Subject: Reply to a Notice of Nonconformance, Request for additional information

Docket No: 99901461  
Reference NRC Inspection Report No. 99901461/2015-201  
Nonconformance 99901461/2015-201-03

**NRC request for additional information:**

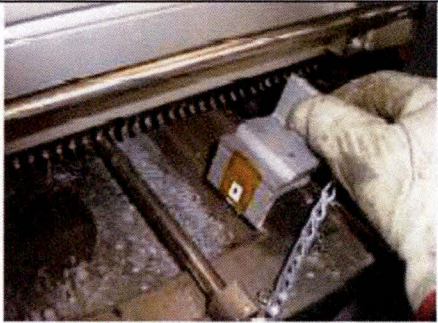
Please describe how Canberra has evaluated any additional critical parameters effecting WSM performance. Additionally, please describe the extent-of-condition review to determine the potential adverse impact of using alternatives to manufacturer recommendations on other solder machines or during other solder procedures effecting safety-related components. The inspectors are specifically interested in control of any induced latent failure modes that could affect seismic and other qualifications not detected by the Canberra post soldering inspection process.

**With a gloved hand install the solder level fixture as shown on either front side of the solder pot.**

**Verify the solder level at a minimum is at the bottom of the solder level fixture. If not, add solder to the pot accordingly.**
